# Taronga Zoo – Upper Australia Precinct Modification 1

Replacement of approved Koala exhibit with a Dingo exhibit, amend the landscaping and fence design, increase tree removal and biodiversity offsets and amend conditions relating to bushfire management

State Significant Development Modification Assessment  
(SSD 10456 MOD 1)

August 2021

**Figure 9 | Exhibit Layout: approved (left), proposed (right) (source: Applicant)**

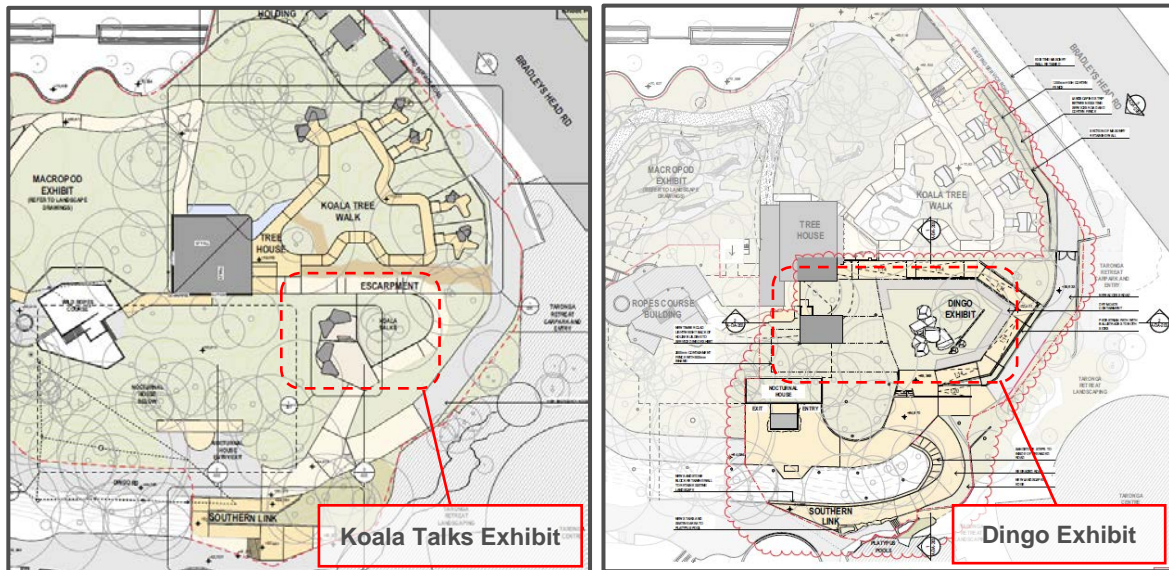
Aspect	Proposed Change
<b>Change in Exhibit Layout</b>	<ul style="list-style-type: none"> <li>Change the approved koala exhibit area (Koala Talks) to a Dingo exhibit (<b>Figure 9</b>).</li> </ul>
<b>Bradley's Head Fence</b>	<ul style="list-style-type: none"> <li>Amend the Bradley's Head Road fence design to a smaller 'koala containment fence'. As the revised fence will be of a more permeable design, the modification seeks to remove the Aboriginal artwork originally incorporated (<b>Figure 10</b>).</li> </ul>
<b>Access</b>	<ul style="list-style-type: none"> <li>Changes to the Southern Link walkway and the dingo exhibit pathway (<b>Figure 9</b>).</li> </ul>
<b>Tree Removal</b>	<ul style="list-style-type: none"> <li>Removal of 6 additional trees previously identified for retention.</li> </ul>
<b>Condition B16 Fire Safety</b>	<ul style="list-style-type: none"> <li>Wording proposed to be amended (wording below).</li> </ul>

**Figure 9 | Exhibit Layout: approved (left), proposed (right) (source: Applicant)**

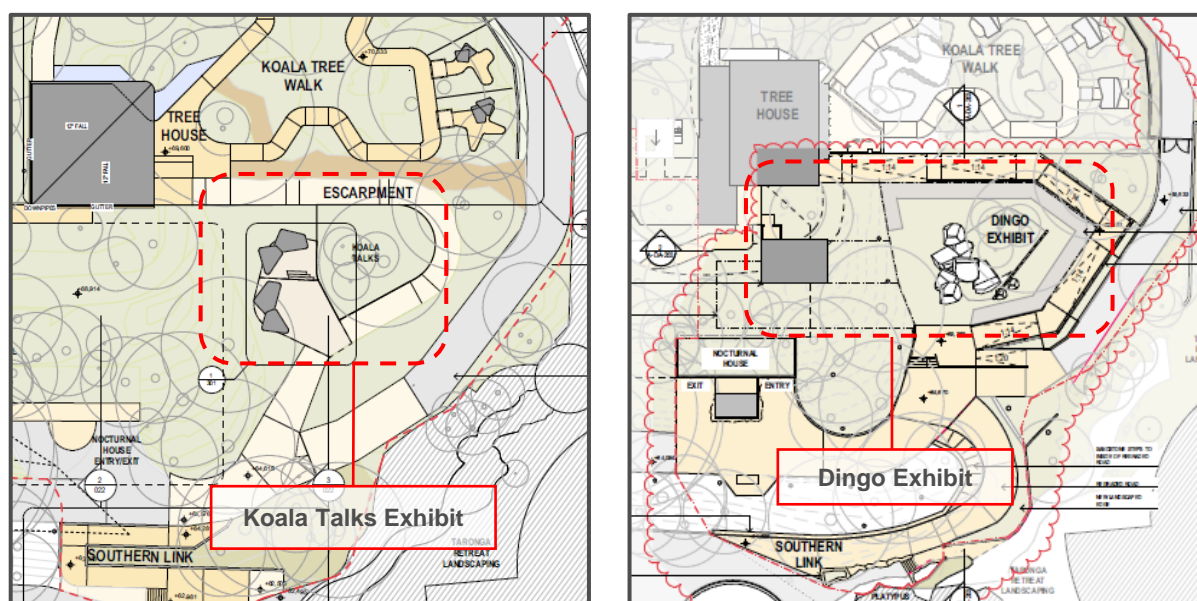
The approved development included a koala exhibit area ('Koala Talks'). The proposed modification seeks to replace the Koala Exhibit with a Dingo exhibit, as shown in **Figure 11**. The Applicant advised the reason for the change is that the area previously intended to be a koala exhibit area (Koala Talks) is no longer considered to provide positive animal welfare conditions for koalas.

The exhibit area has been increased to ensure adequate space and a high standard of welfare is provided for the dingoes. To accommodate the dingoes, the landscaping of the exhibit has been modified, including the addition of rocks/boulders and trees (discussed further in **Section 5.4**). The exhibit would also be partially surrounded with a dry moat containment.

The Department considers the revised exhibit layout to be acceptable as it would result in minimal changes to the overall built form of the Upper Australia Precinct.

The Department therefore concludes the revised exhibit layout is acceptable.

**Figure 10 | Dingo BOH Building: Ground Floor Plan (above), N/S section (below) (source: Applicant)**

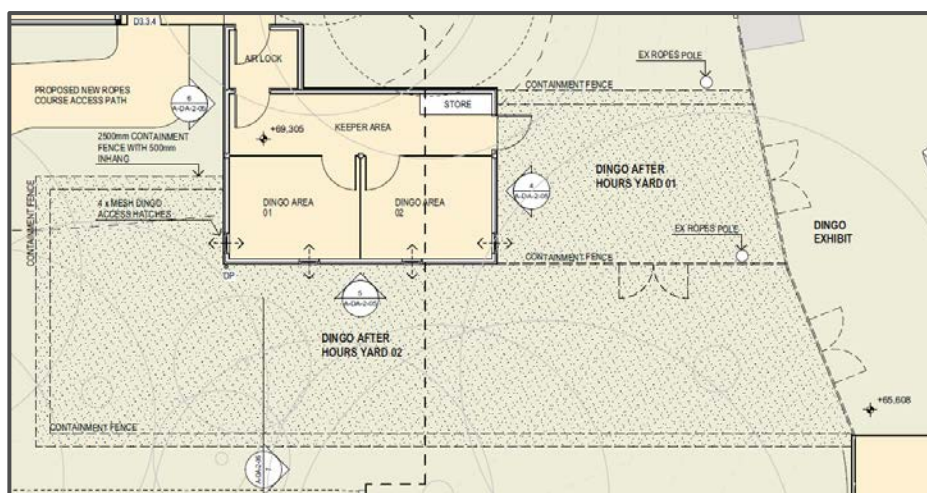
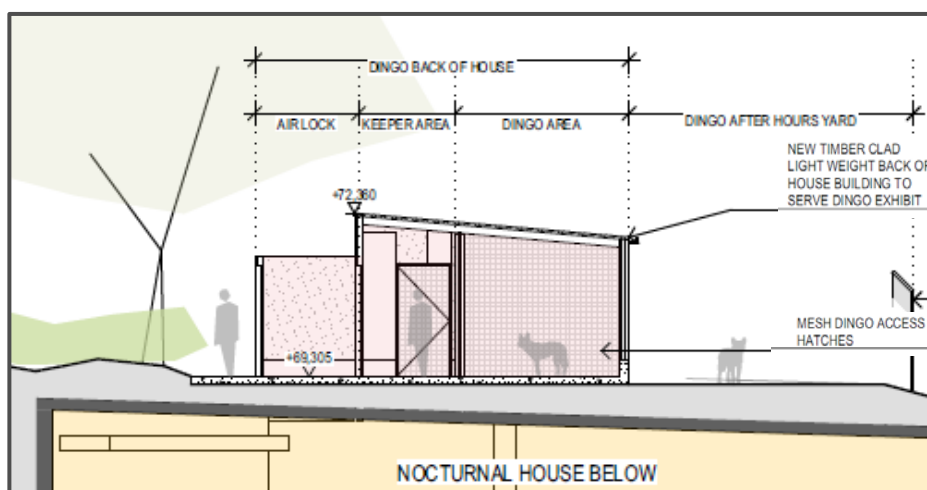
In addition to the main dingo exhibit, the modification includes a back-of-house (BOH) building and two dingo after hours yards, as shown in **Figure 12**. In terms of mass, the BOH building will have an area of 45 m<sup>2</sup> with a maximum height of 3 m to service the dingo exhibit. The BOH building will utilise materials consistent with the Tree House Building, including weatherboard timber cladding, a Colourbond roof and black chainlink mesh.

**Figure 11 |** Additional trees proposed to be removed highlighted in red (source: Applicant's Arborist report and Addendum Arborist Report)

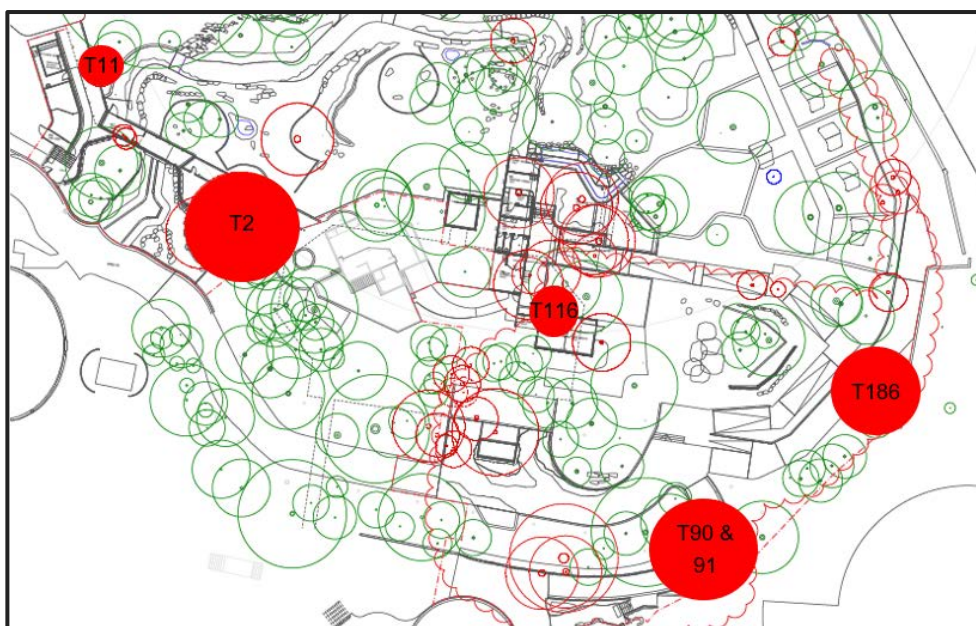
The approved development involved the removal of 37 trees to facilitate the works. The modification proposes to remove an additional 6 trees, resulting in a cumulative loss of 41 trees. The additional trees to be removed are shown in **Table 4** and **Figure 13** below.

Tree #	Species	Significance	Reason
2	Broad-leaved paperbark (Melaleuca quinquenervia)	Low	<ul style="list-style-type: none"> <li>• The tree was intended to be retained as part of the original approval; however, the assessment found a significant defect with a basal termite infection reducing the structural integrity of the tree.</li> <li>• Approved plans include a deck with a major encroachment into the Structural Root Zone (SRZ) .</li> <li>• While the deck could be installed with tree sensitive design, the current health of the tree poses a high risk of tree failure.</li> </ul>
11	Water Gum (Tristania laurina)	Low	<ul style="list-style-type: none"> <li>• The tree was intended to be retained as part of the original approval; however, following early works on site the development was determined to impact the tree.</li> <li>• Approved plans include a ramp of sandstone spalls transitioning into a boardwalk with a major</li> </ul>

The AIA identified the trees to be removed are of low (4) to medium (2) significance within the landscape, as shown in **Table 4**. None of the trees proposed to be removed are of heritage significance. The findings of the AIA (and addendum AIA) were that the removal of the 6 additional trees could be supported to facilitate the development.

The Department considers the additional tree removal and biodiversity impacts are acceptable as:

- none of the additional trees to be removed are of heritage significance and of the 6 additional trees to be removed 2 are of medium significance within the landscape, with the remaining of low significance
- existing conditions ensure the trees to be retained are be managed in accordance with recommendations detailed in the AIA and addendum AIA
- biodiversity impacts would continue to be managed in accordance with management measures detailed in the original and updated BDAR.
- EESG support the proposal and the increased biodiversity offset requirements.

The Department therefore recommends Condition B24 (Biodiversity Offsets) be updated to reflect the revised biodiversity offset credit requirements.

**Figure 13 | Zone 5 Landscaping Plan: approved (left), proposed (right) (source: Applicant)**

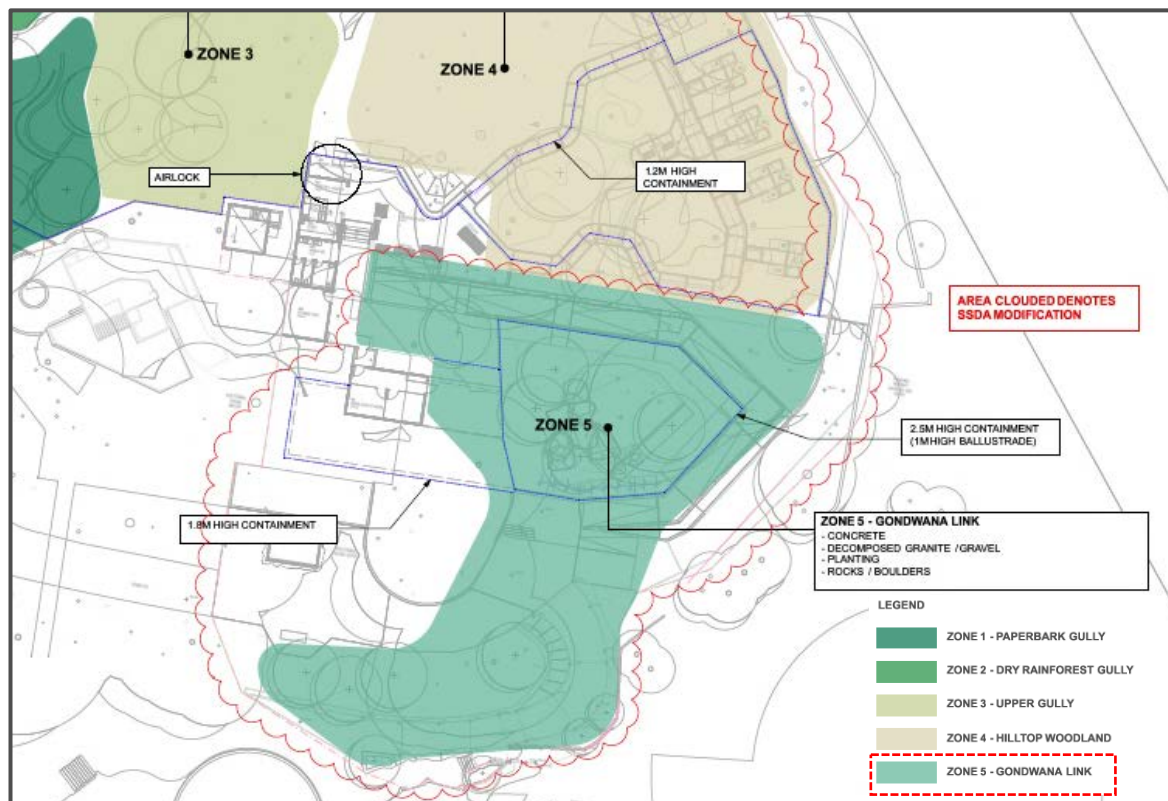
The proposed modification seeks to make changes to the landscaping of Zone 5 ‘Gondwana Link’, as shown in **Figure 14** below.

These changes are to ensure the exhibit can provide adequate animal welfare to dingoes, as opposed to Koalas. The changes include the addition of rocks/boulders and planted vegetation such as trees and a 2.5 m high containment fence and partially surrounded by a dry moat containment. The approved and proposed Landscape Plan for Zone 5 is shown in **Figure 15** below.

The Department notes the exhibit area has been increased to ensure adequate space and a high standard of welfare is provided for the dingoes, which has resulting in amendments to the pathway surrounding the exhibit. In addition to this, the proposed modification seeks to make changes to the Southern Link pathway as shown in **Figure 15**.

The Department considers the landscaping to be acceptable as it provides for the ongoing welfare of dingoes in the exhibit and would not significantly change the appearance of the approved development.
